HEARING DATE: March 12, 2024

TO: Mayor & City Council

SUBJECT: Avani Neighborhood AZ, PP  
H-2023-0049

Annexation of 35.086 acres of land to the R-15 (Medium-high-density residential) zoning district; and Preliminary Plat consisting of 256 building lots and 25 common lots on 33.71-acres of land in the R-15 zoning district for Avani Neighborhood Subdivision.

FIGURE 1

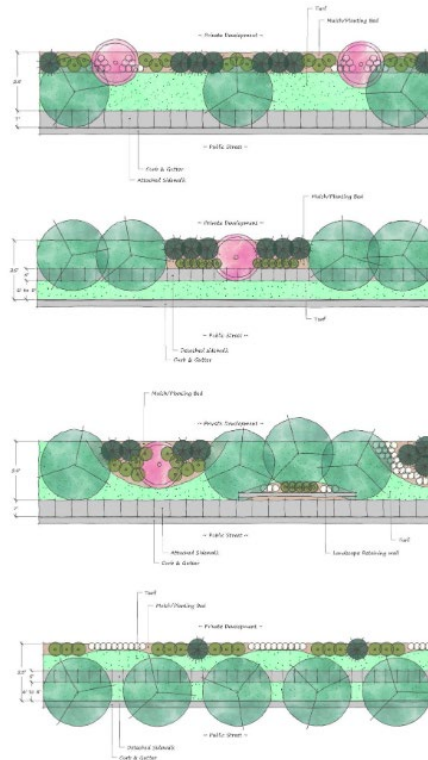
**Landscaping (UDC [11-3B](#)):** A 25-foot wide street buffer is required is required along all arterial streets (i.e. S. Black Cat Road) in residential districts. A 20-foot wide street buffer is required along all collector streets (i.e. Vantage Point Way) a collector street, per UDC [Table 11-2D-7](#), landscaped per the *updated* standards listed in UDC [11-3B-7C](#). **The proposed buffer along the southern half of Black Cat Road appears to be 20-feet in width and should be 25-feet in width. The 20-foot wide buffer along the new collector street (Vanguard Way) appears to meet the requirements of the UDC code; however, there is a lack of a combination of planters (shrubs and rock mulch) within both of the buffers (refer to the figures below).**

C. Preliminary Plat (dated: 10/18/23) – NOT APPROVED

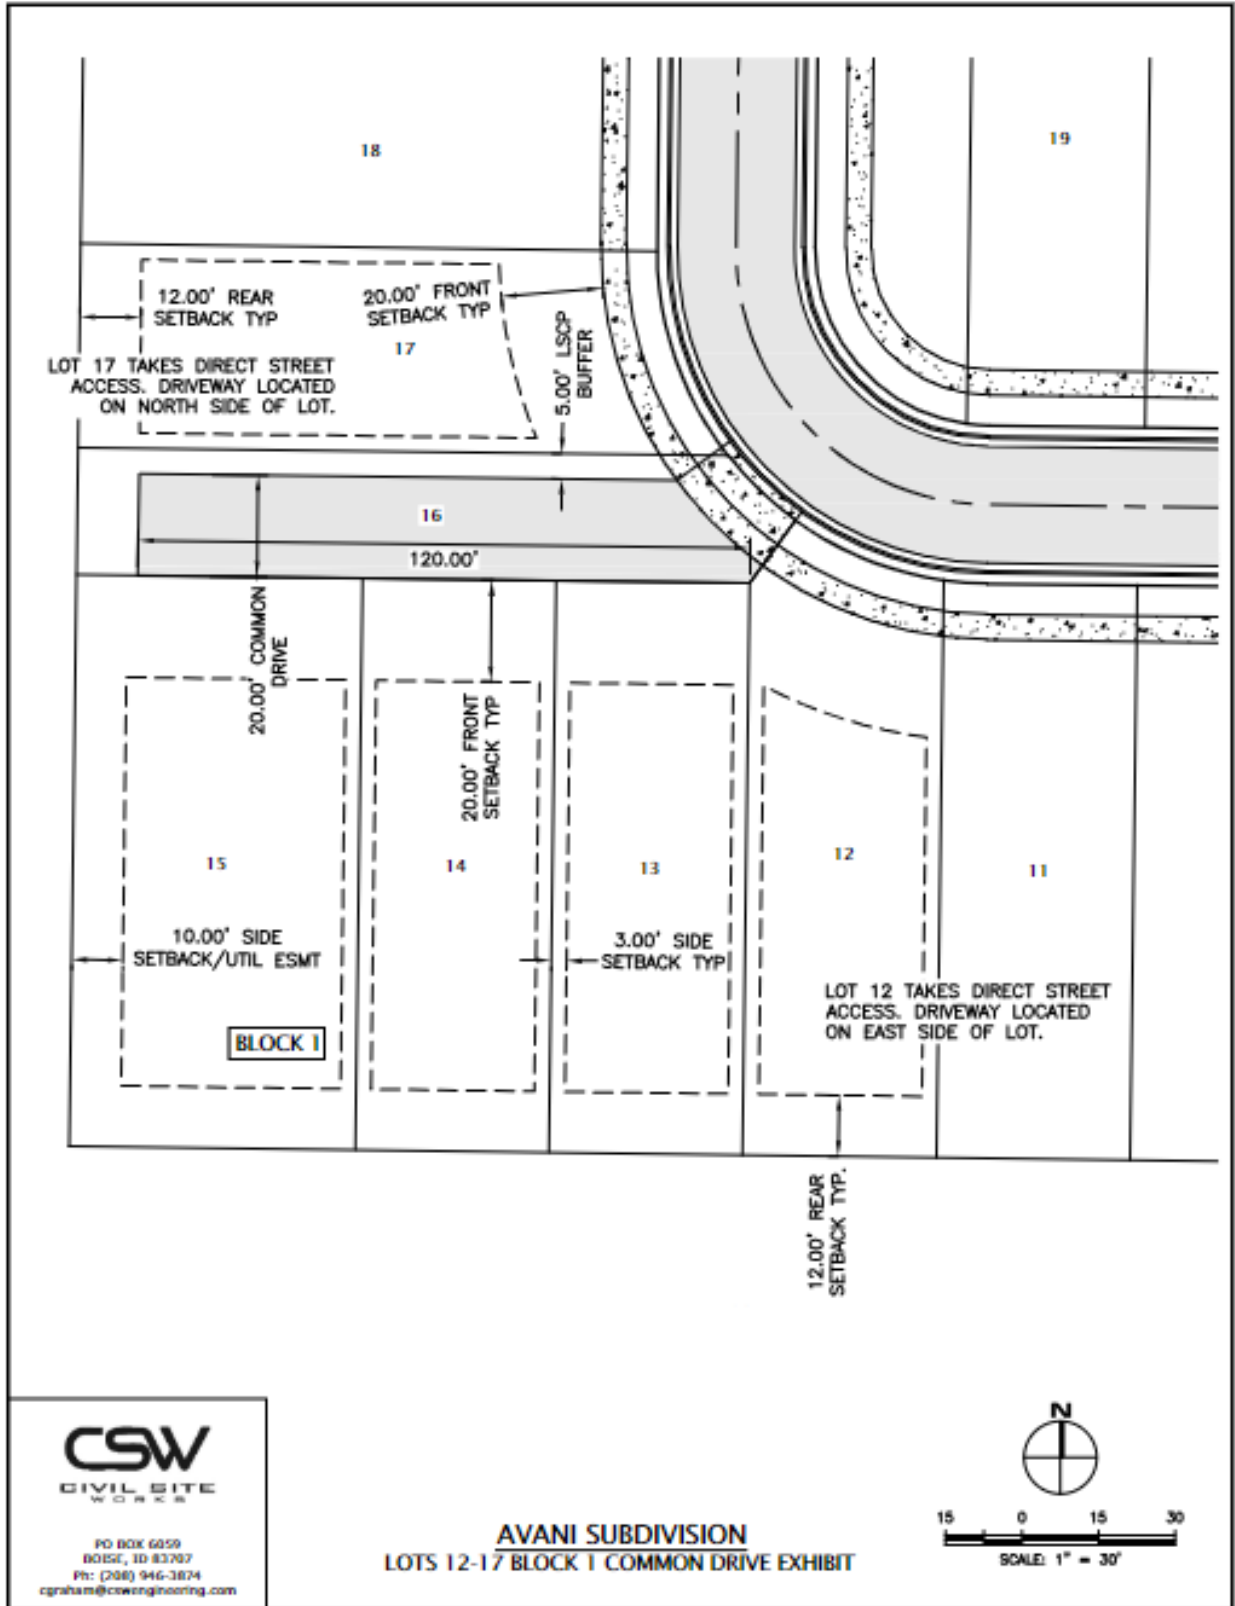
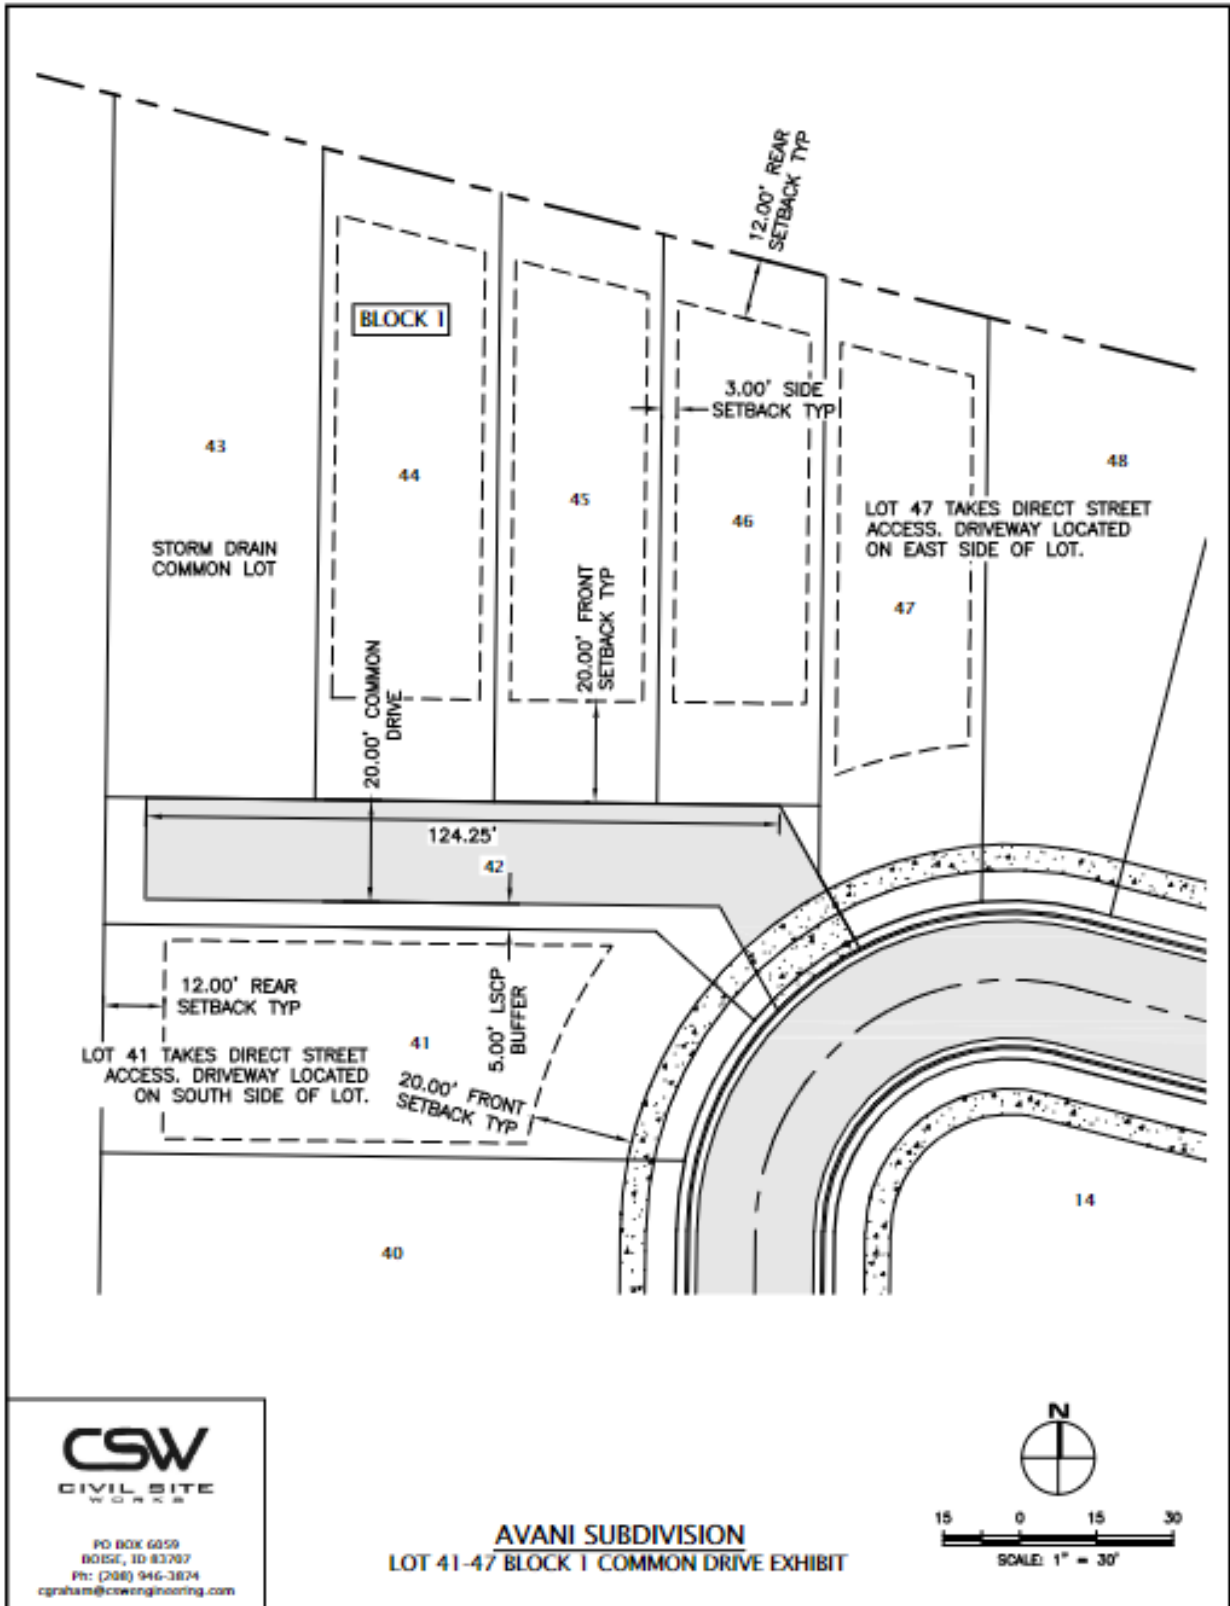
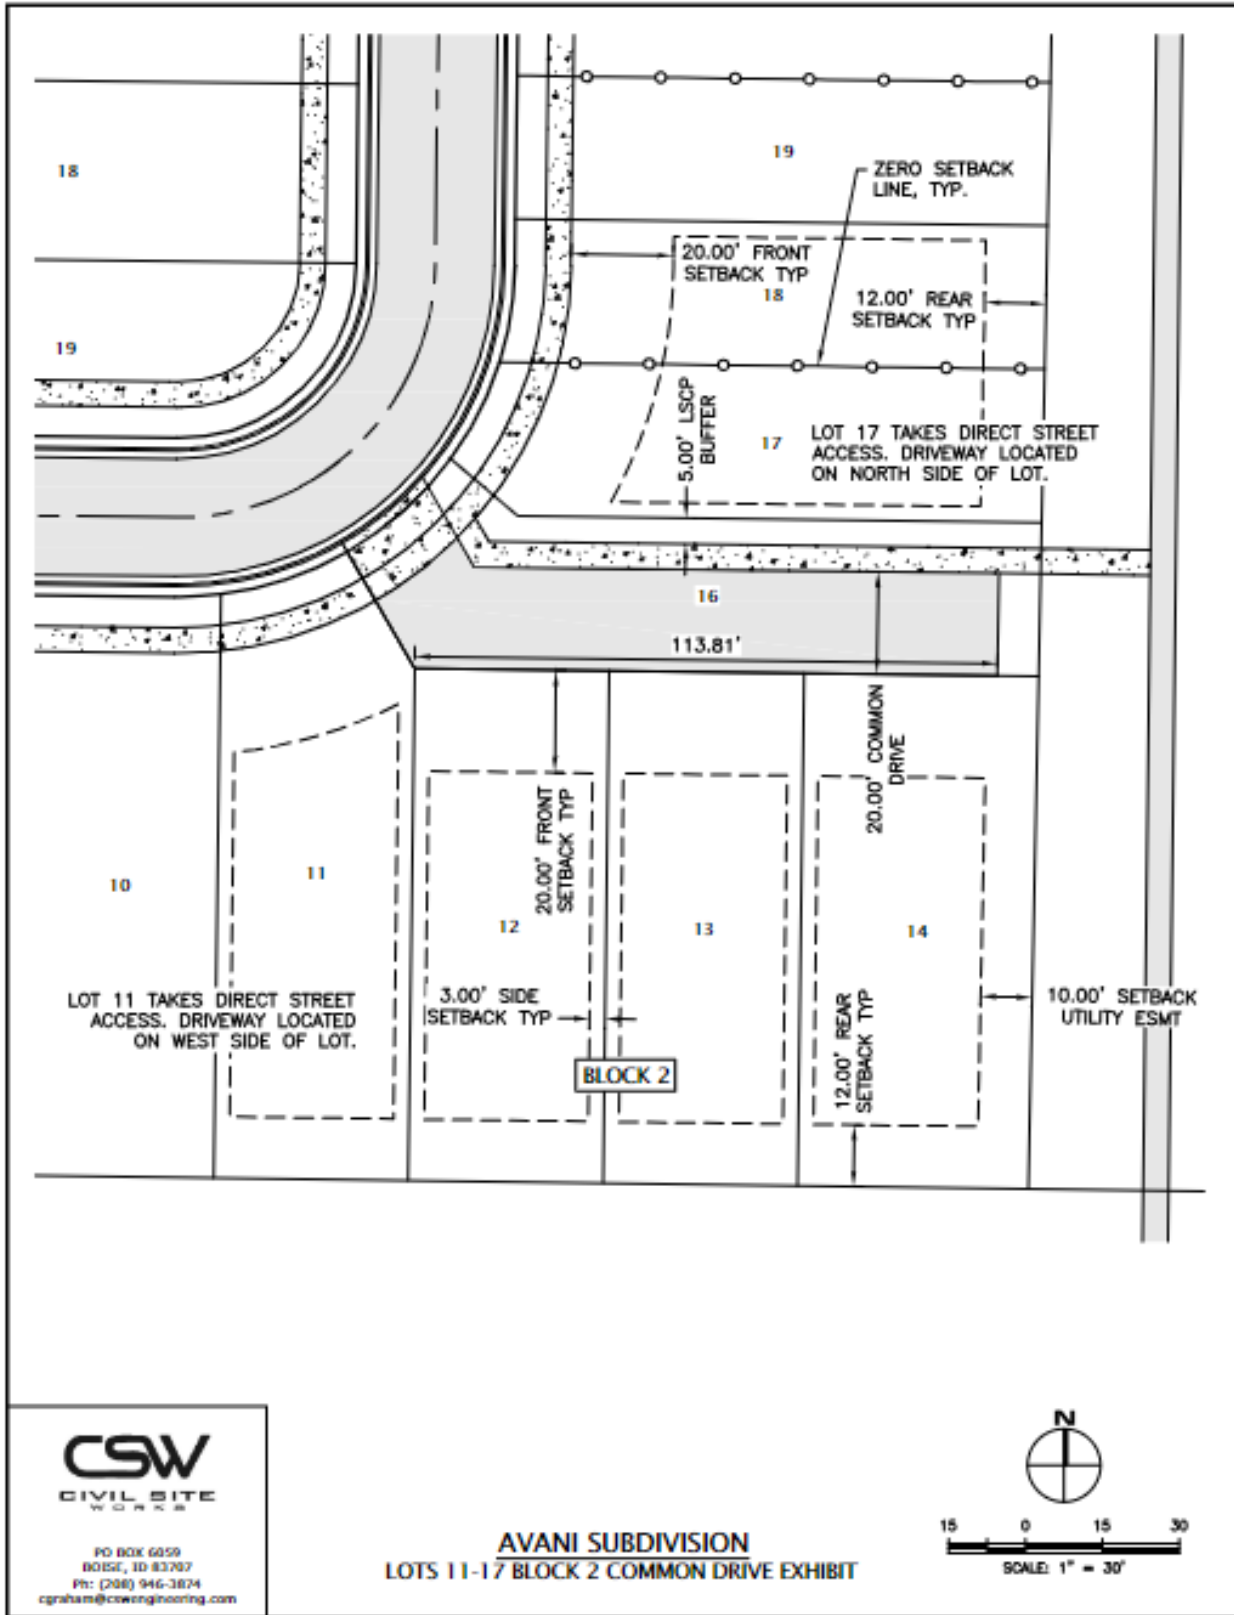
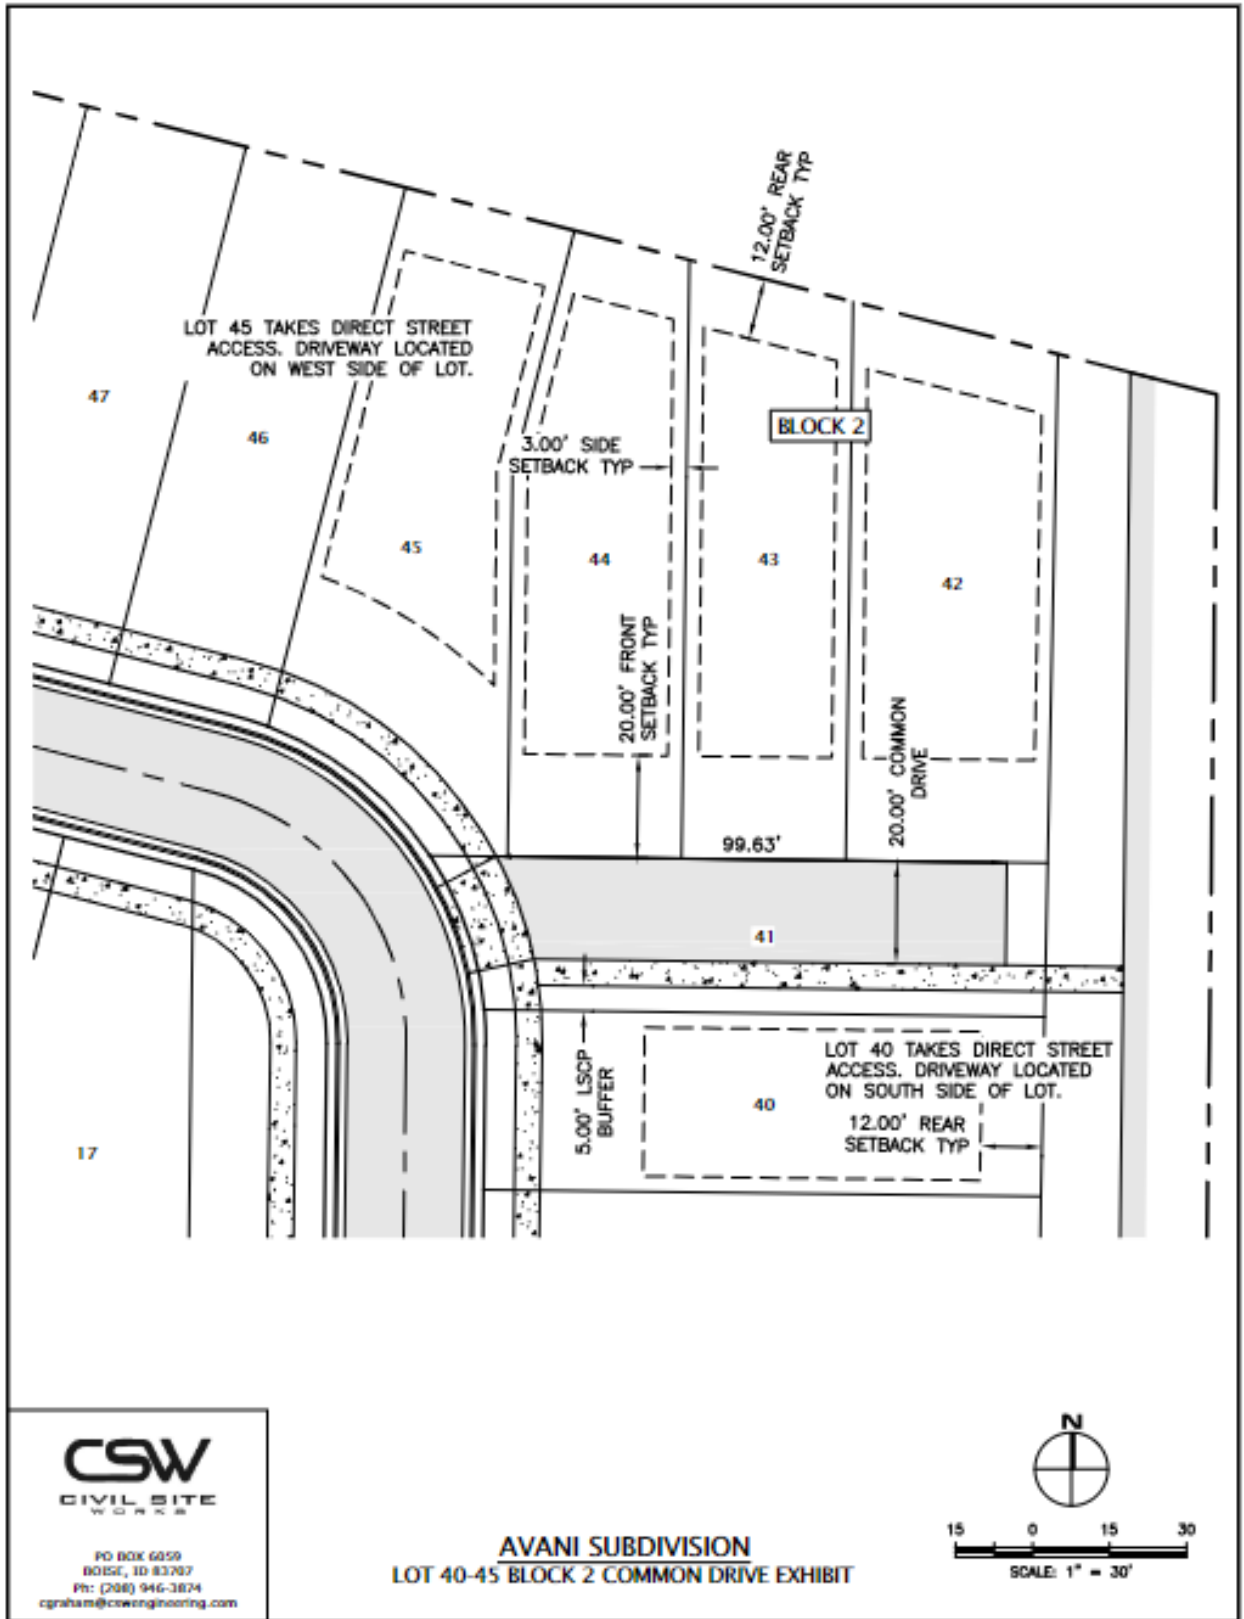
Local streets, alleys, and common drives are proposed internally for access to the proposed residential units. **Staff believes the plat should incorporate more alley-loaded lots however, the Applicant believes there isn’t a market for this type of housing and has elected to limit the number of alley-loaded homes to ten (10) which is inconsistent with the Plan.**

*Out of the 256 single-family units, only 10 are alley-loaded; the others are all front-loaded with living area either at the same plane or behind the garages away from the street. A few of the units have usable porches that might meet the guidelines. No porches are proposed on the side facades. All units have single 2-car garage doors, not separate doors.*

A preliminary plat is proposed consisting of 256 [95 single-family attached, 10 alley-loaded, and 151 single-family detached units] building lots and 25 landscape, six (6) common driveways, two (2) alleys, and one (1) non-buildable lot on 33.707-acres of land in the R-15 district. Proposed lots range in size

**Common Driveway (UDC [11-6C-3D](#)):** Six (6) common driveways are proposed within the development of the site on Lot 42, Block 1, Lot 16, Block 1, Lot 41, Block 2, Lot 33, Block 2, Lot 16, Block, 2, and Lot 23, Block 5. Common driveways are allowed to serve a maximum of four (4) dwelling units; in no case shall more than three (3) dwelling units be located on one (1) side of the driveway. **A total of four (4) dwelling units are proposed on the south side of driveway for Lot 23, Block 5; the final plat and common driveway exhibit shall be revised to depict a maximum of three (3) units on one (1) side of the driveway as required; or, alternative compliance may be requested as set forth in UDC [11-5B-5](#).**

**The proposed elevations are *not* approved and should be revised to incorporate traditional neighborhood design elements as set forth in the TMISAP, as noted above in Section V, and in the Architectural Standards Manual (ASM).**
